Response to NRC Review Questions

LaCrosse Boiling Water Reactor
Dairyland Power Cooperative
Genoa, Wisconsin 54632

Re: Response to NRC Review Questions

We are submitting ten copies of the report "Response to NRC Review Questions, Seismic Hazard and Liquefaction Potential at LACBWR Site, near Genoa, Vernon County, Wisconsin" for your use. This report contains answers to all the questions raised by the Nuclear Regulatory Commission (NRC) in their letter of April 25, 1980, to Dairyland Power Cooperative (DPC).

Figure 2a-1
Standard Penetration Resistance Data Close to Existing Hospital,
Normalized to 1 ton/ft² Overburden

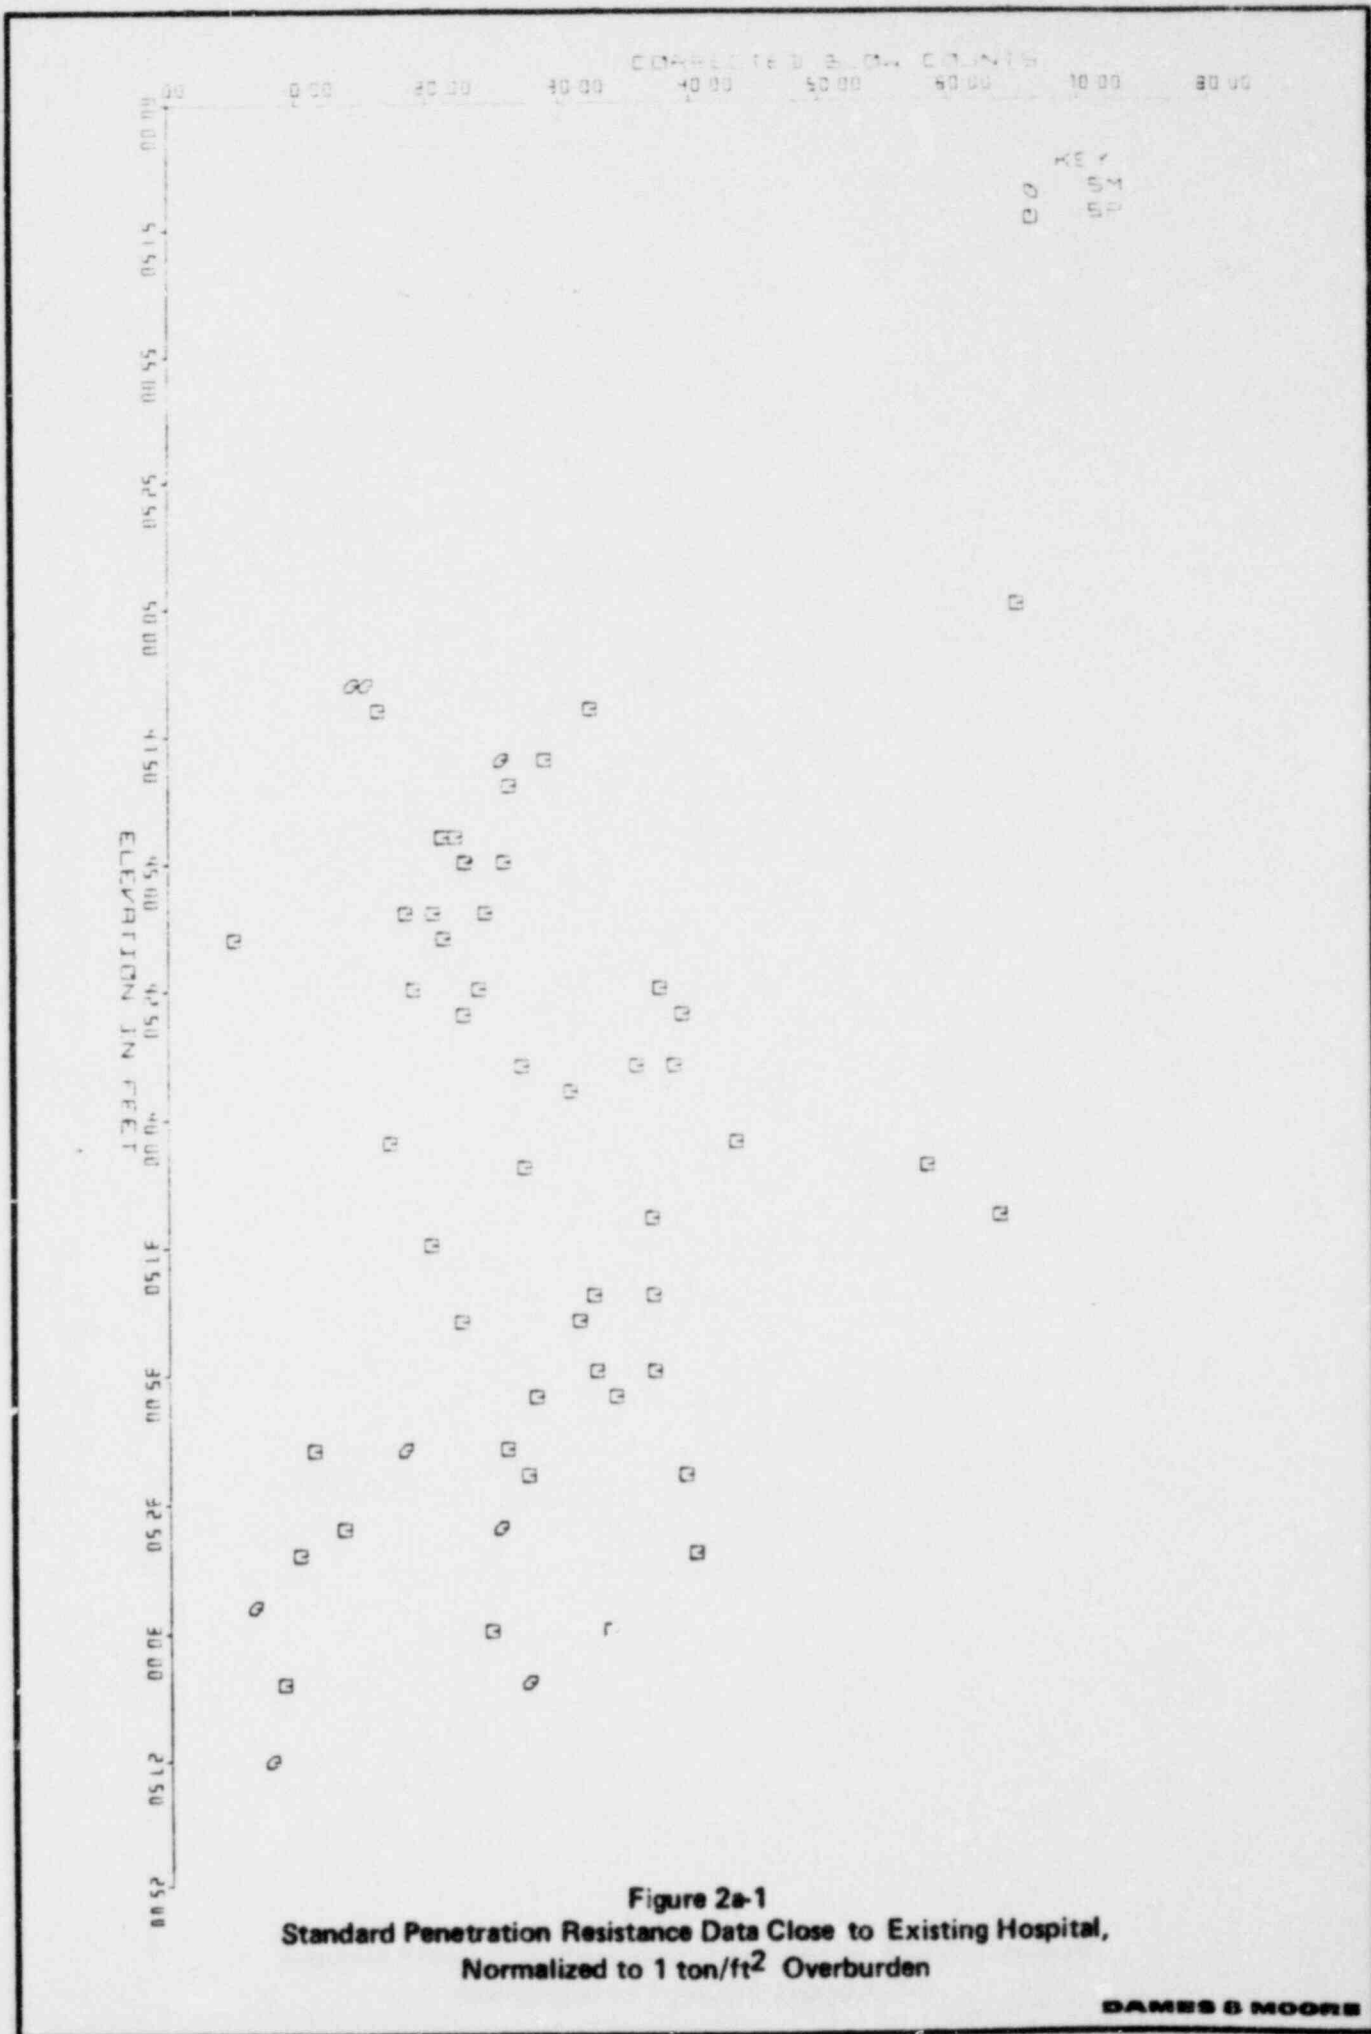
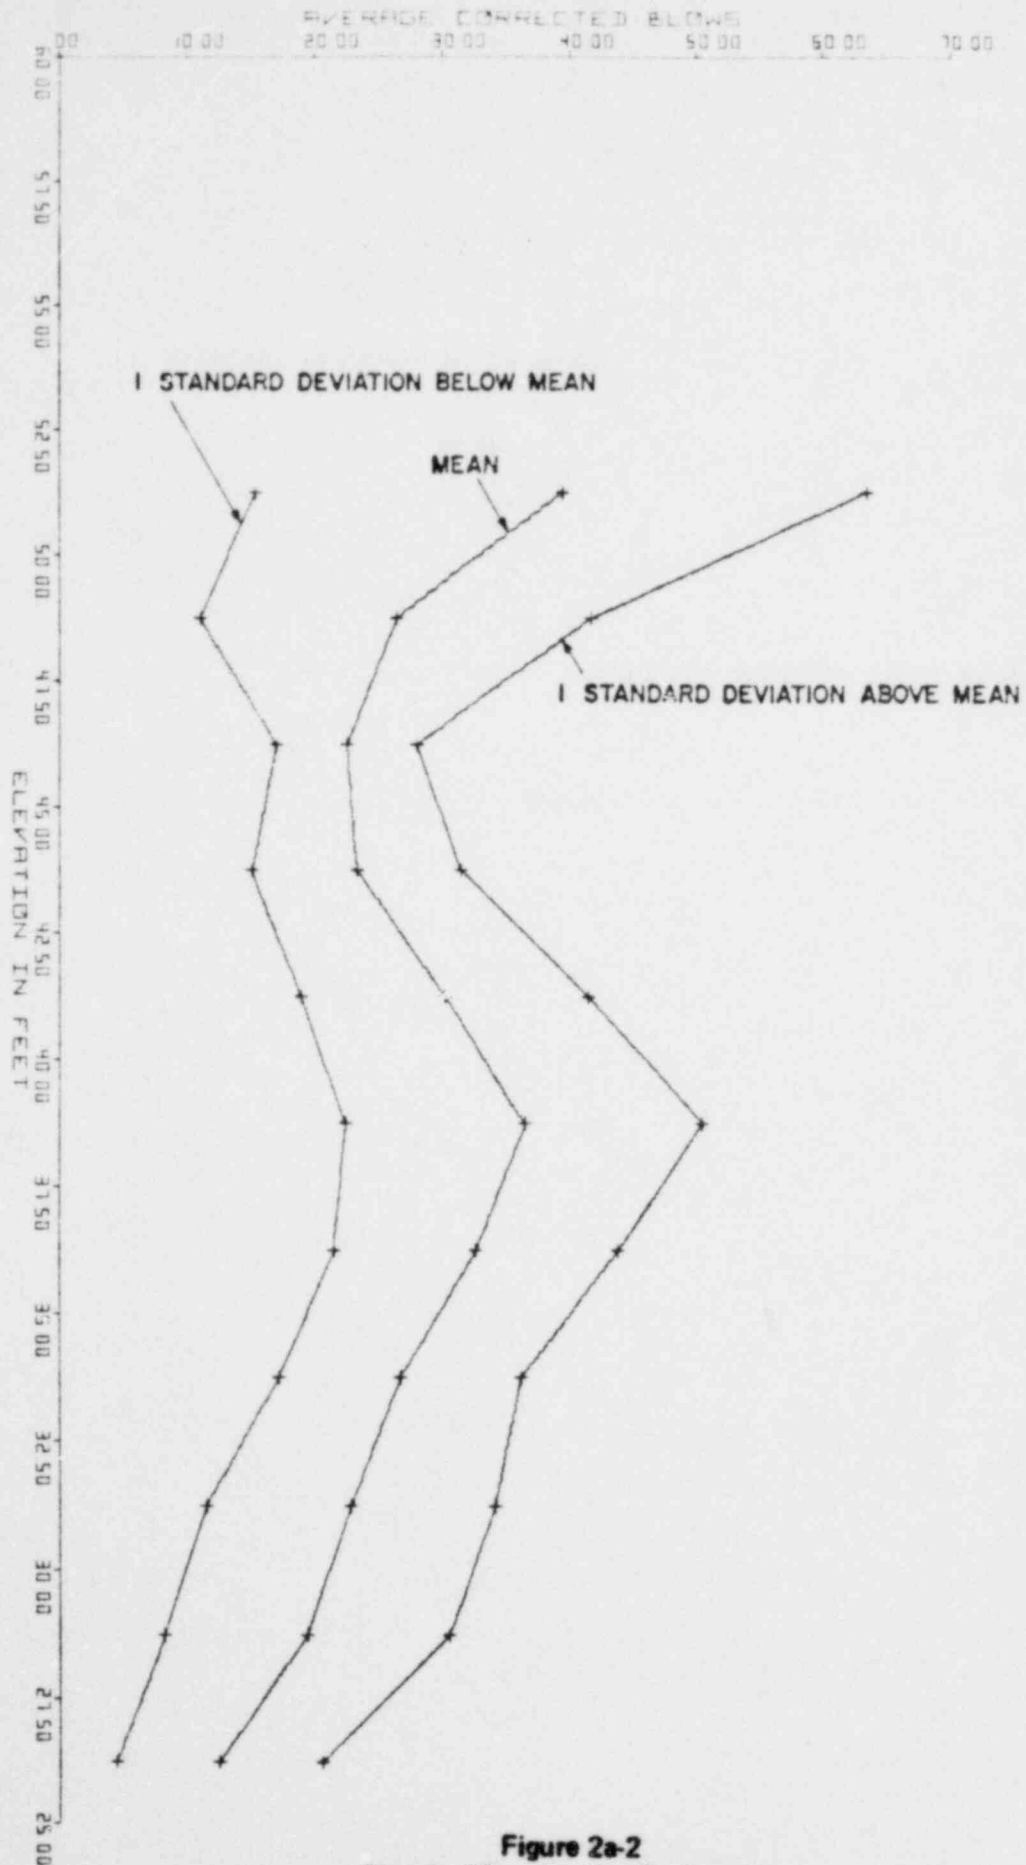
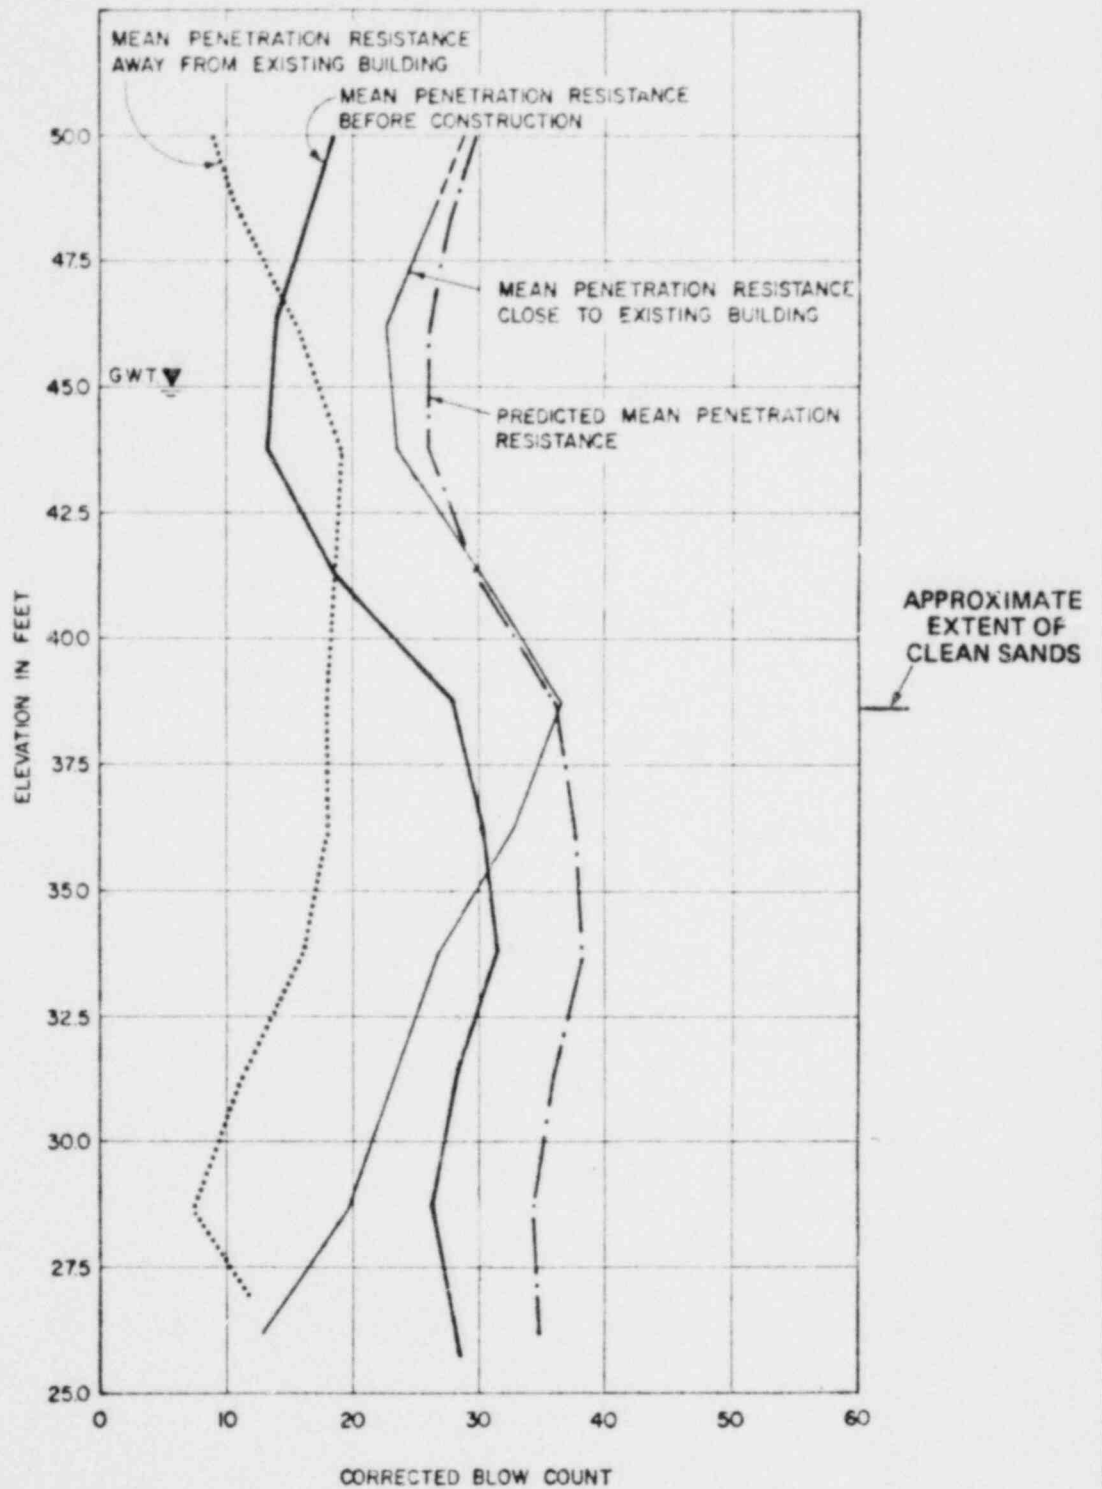
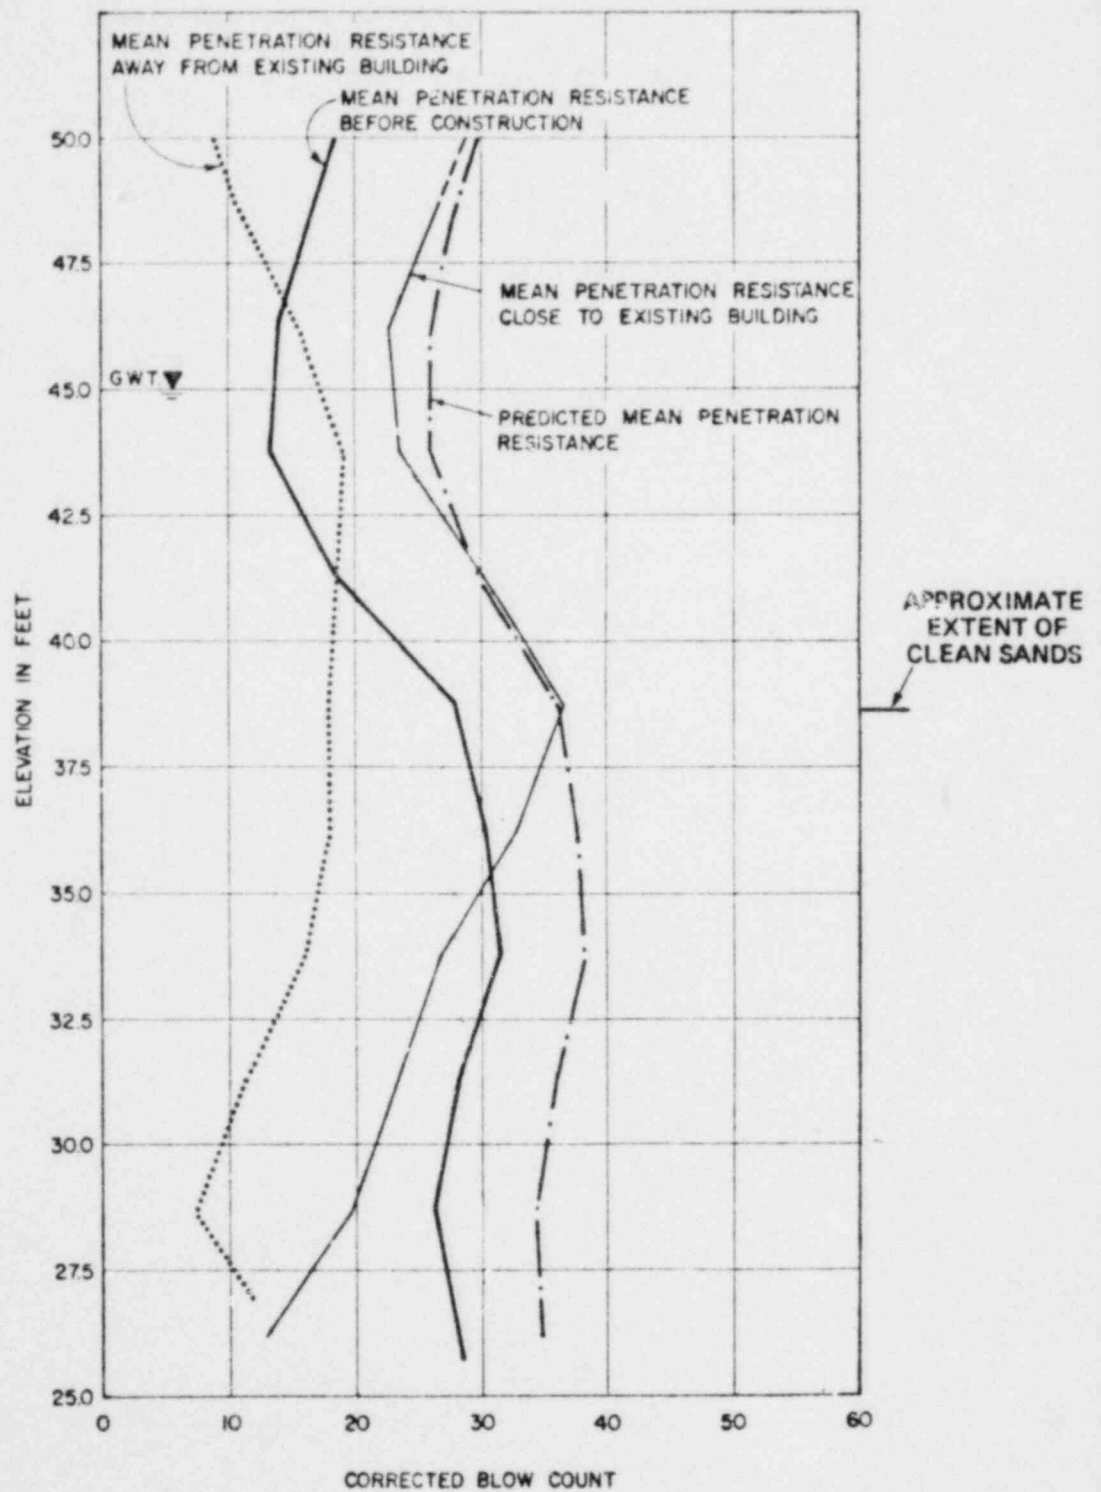
Question 2a

As explained in the Response dated March 21, 1980 (reference I-5), a recent D&M project (reference 2a-1) documented a study in which the increases in SPT (Standard Penetration Test) blow counts due to the effects of pile driving and placement of fill were predicted and subsequently verified through a test boring program. A relation was assumed between confining pressure, relative density, and overconsolidation ratio as explained in the Response. Pile driving was assumed to increase the at-rest earth pressure coefficient and the relative density of the soil. Based on these assumptions and on SPT data from the site before original construction, predictions of increased N values were made. A field program was then carried out in which blow counts taken close to the building compared well with the predicted values, especially in clean sands.

Attached are plates from reference 2a-1, showing normalized SPT data close to the structure (figure 2a-1), mean and standard deviation values of normalized SPT data close to the structure (figure 2a-2), and comparison of average SPT results as predicted and measured (figure 2a-3).
